UNITED STATES
DEPARTMENT OF THE INTERIOR
GEOLOGICAL SURVEY

J. Apache "B"

15

(Other) Amend location as above

NEW MEXICO OIL CONSERVATION COMMISSION
WELL LOCATION AND ACREAGE DEDICATION PLAT

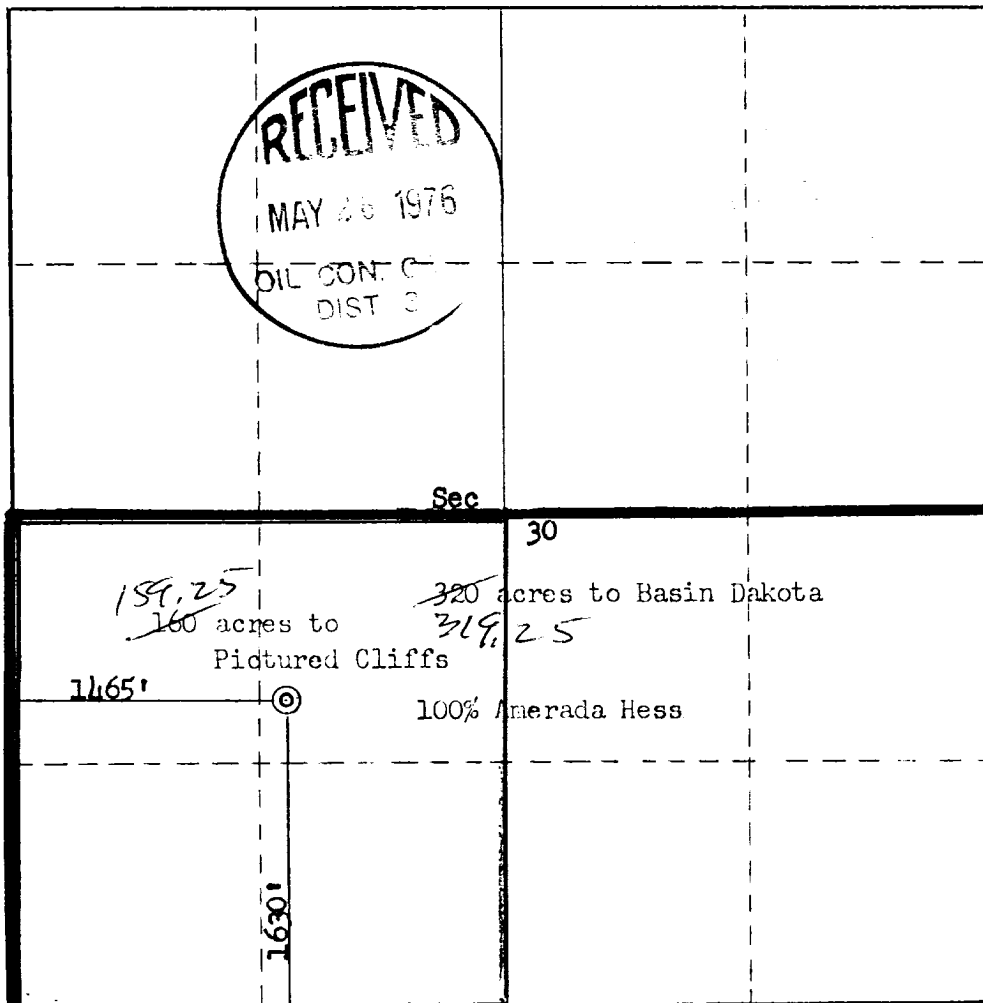
Amended to - 1630' FSL and 1465' FWL

Amended to 6561' Gr. Elevation

Footage and ground elevation amended as above.

Operator Amerada Hess Corporation			Lease Jicarilla Apache		Well No. B-15
Unit Letter K	Section 30	Township 24N	Range 5W	County Rio Arriba	
Actual Footage Location of Well: 1630 feet from the South line and 1465 feet from the West line					
Ground Level Elev. 6561	Producing Formation Basin Dakota-Pictured Cliffs		Pool Basin/Dakota-Pictured Cliffs	Dedicated Acreage; see below Acres
